# CITY OF OREGON CITY

**FILE NO.:** L-01-04

**REQUEST:** Review and Recommendation of Approval of the Oregon City Waterfront Master Plan

**REQUEST:** Preliminary Plan for a phased Planned Unit Development of 29 units on 20 lots (17 single family and 12 multi-family units).

FIGURE 3

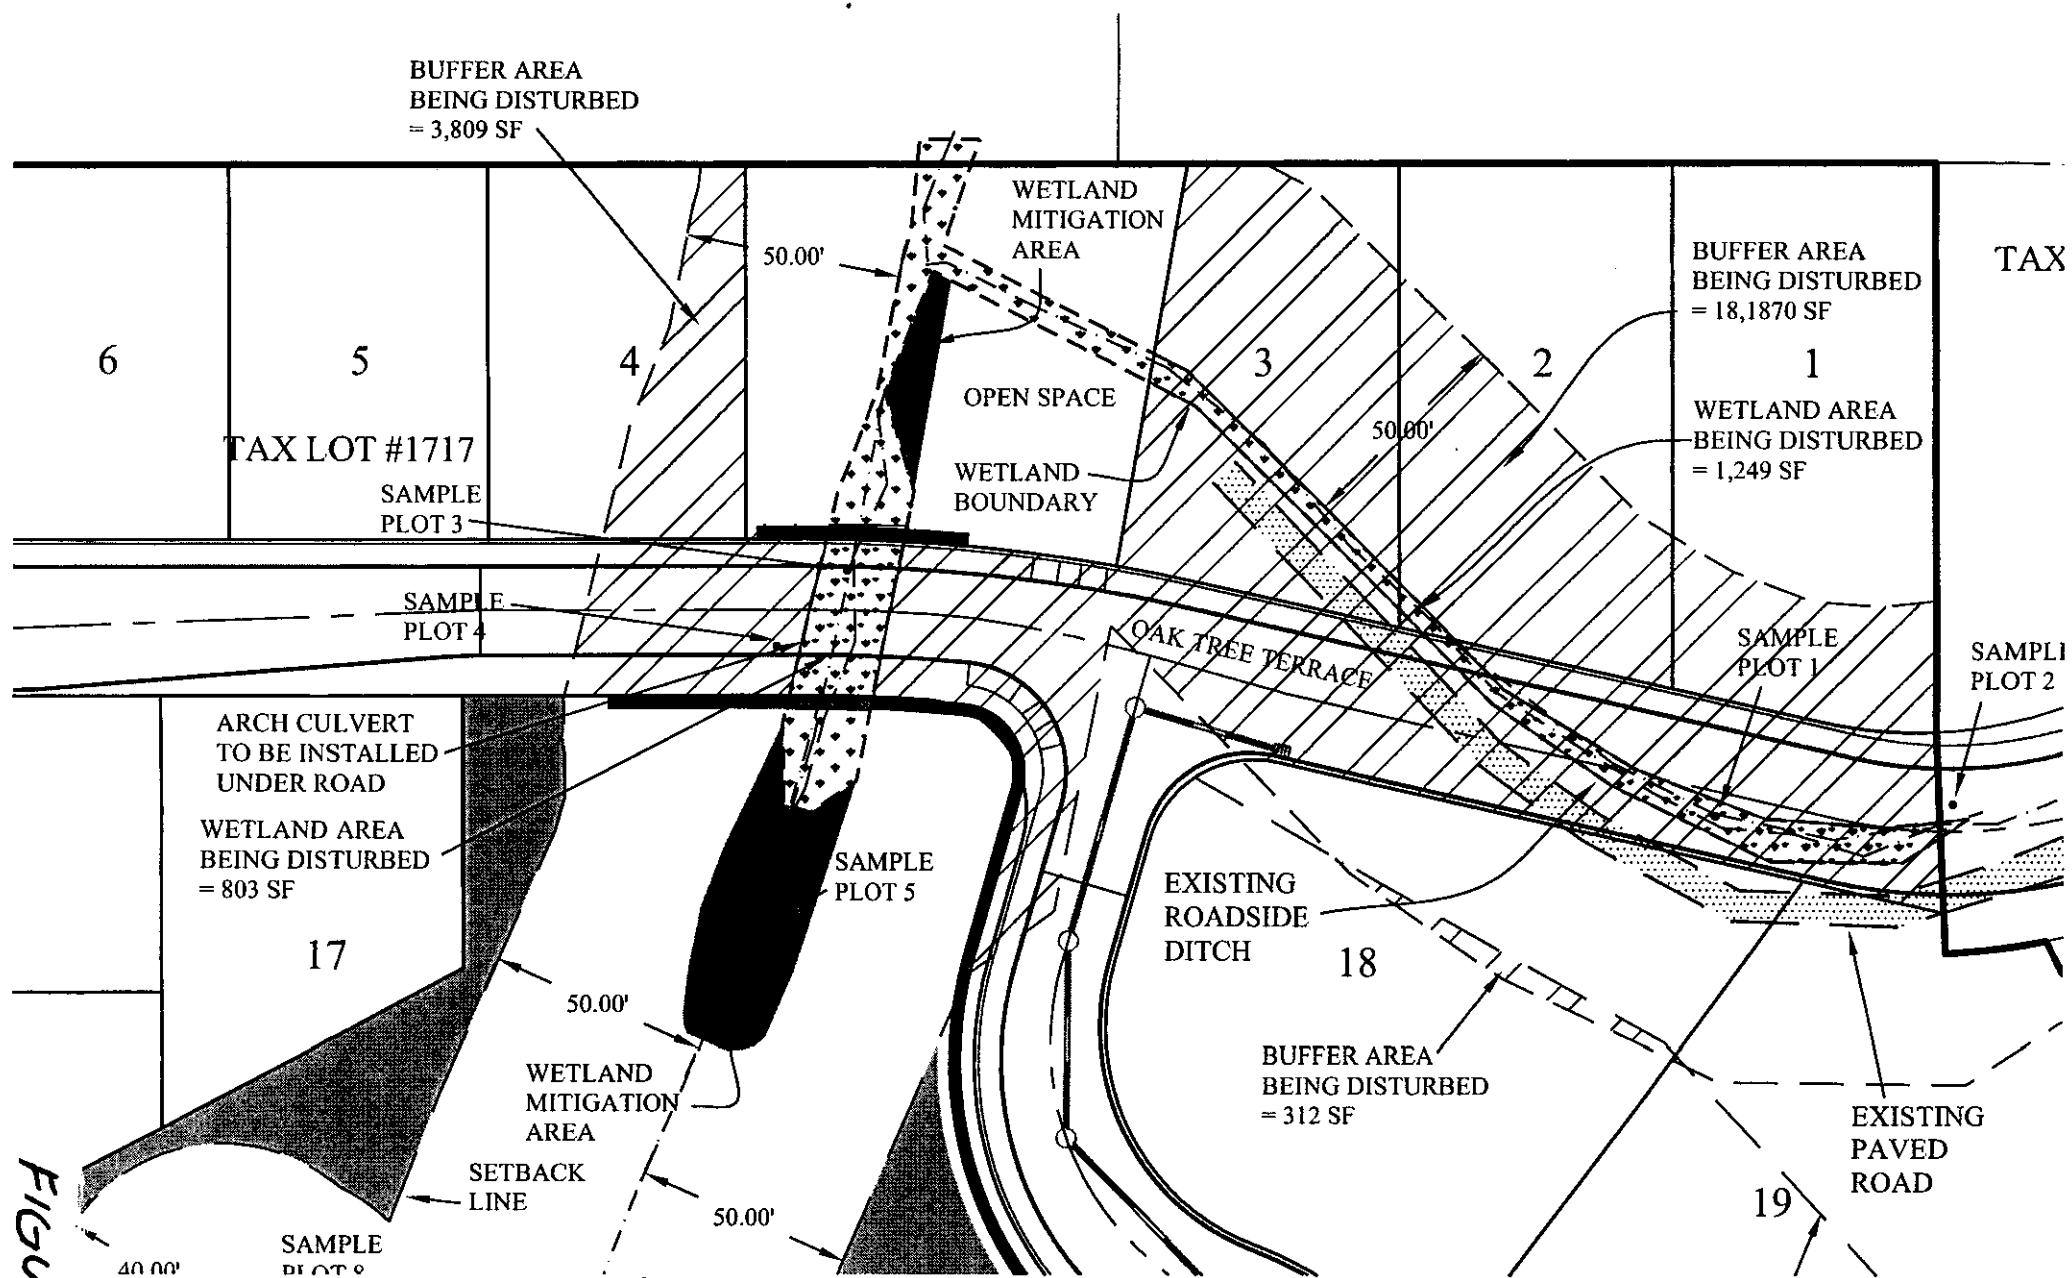
The Water Resources Report Addendum analyzes conceptual mitigation for impacts on the WQRA. The original conceptual mitigation plan contained in the March 2001 report has been voided by the revised PUD design. Wetland impacts were reduced by the revised plan compared to the original PUD design. Retaining part of the wetland on the site allows a better mitigation plan by enhancing the remaining wetland and creating new wetland immediately adjacent. Creation of a wetland area at a 1.5 to 1 ratio requires 3,078 square feet (0.07 acres). The applicant (through the Fishman addendum) proposes a conceptual mitigation plan and vegetated corridor enhancement plan at this stage. Figures 2 and 3 in the Addendum show the proposed mitigation areas.
